Project	IEEE 802.16 Broadband Wireless Access Working Group < http://ieee802.org/16 >	
Title	Clarification on uplink MIMO for relay station with multiple antennas	
Date Submitted	2007-11-14	
Source(s)	<p>Anxin Li, Xiangming Li, Hidetoshi Kayama DoCoMo Beijing Labs Haidian District, Beijing, 100080, China</p> <p>Ismail Guvenc, Moo Ryong Jeong, Chia-Chin Chong, Fujio Watanabe DoCoMo USA Labs 3240 Hillview Avenue, Palo Alto, CA</p> <p>D. J. Shyy MITRE 7515 Colshire Drive McLean, VA 22102, USA</p> <p>Wen Tong Nortel 3500 Carling Avenue Ottawa, Ontario K2H 8E9</p> <p>Junhong Hui, D.H. Ahn, Young-il Kim ETRI 161, Gajeong-Dong, Yuseong-Gu, Daejeon, 305-350, Korea</p> <p>Yuefeng Zhou NEC EUROPE</p>	<p>Voice: +8610-82861501 E-mail: {liax,lixm,kayama,gu}@docomolabs-beijing.com.cn</p> <p>Voice: 650-496-4726 E-mail: {iguvenc, Jeong, cchong, watanabe}@docomolabs-usa.com</p> <p>E-mail: djshyy@mitre.org</p> <p>Voice: +613-763-1315 E-mail: wentong@nortel.com</p> <p>Voice: 82-42-860-6496 E-mail: {junhonghui, dhahn, yikim}@etri.re.kr</p> <p>E-mail: Yuefeng.Zhou@ttd.necur.com</p>

Re:	Call for Reply Comments to "IEEE 802.16 Working Group Letter Ballot #28"	
Abstract	The document clarifies the undefin

Figure 306a Mapping of data subcarriers for 3-antenna RS

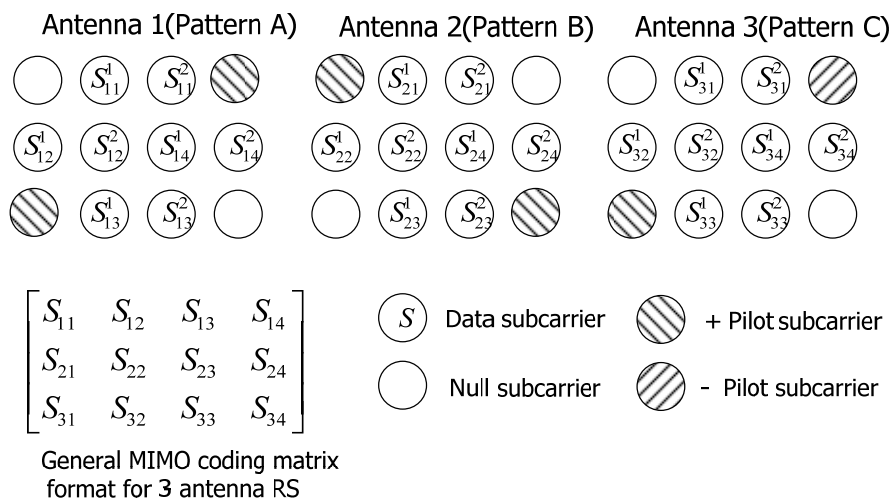
In IEEE 802.16 working group letter ballot #28, some comments point out that the superscripts in figure 306a and 306b are not clearly defined [1][2] and the meaning of the pilot subcarrier are ambiguous [3]. In this contribution, the meanings of the superscripts are clarified and in order to avoid the ambiguous meaning of the pilot subcarrier, the “pilot subcarrier” and “+ pilot subcarrier” are incorporated as “+ pilot subcarrier” in figure 306a and 306b because they have the same meaning.

For RS using three antennas, the MIMO coding matrices defined in 8.4.8.3.4 shall be mapped to the tile according to Figure 306a. **One tile shall contain two MIMO coding matrices, i.e. S^1 and S^2 , which can be A_1, A_2, A_3, B_1, B_2 or B_3 defined in 8.4.8.3.4. The elements of the two MIMO coding matrices should be mapped to tile according to Figure 306a, where S^1_{mn} denotes the m^{th} row n^{th} column element of the first MIMO coding matrix and S^2_{mn} denotes the m^{th} row n^{th} column element of the second MIMO coding matrix.**
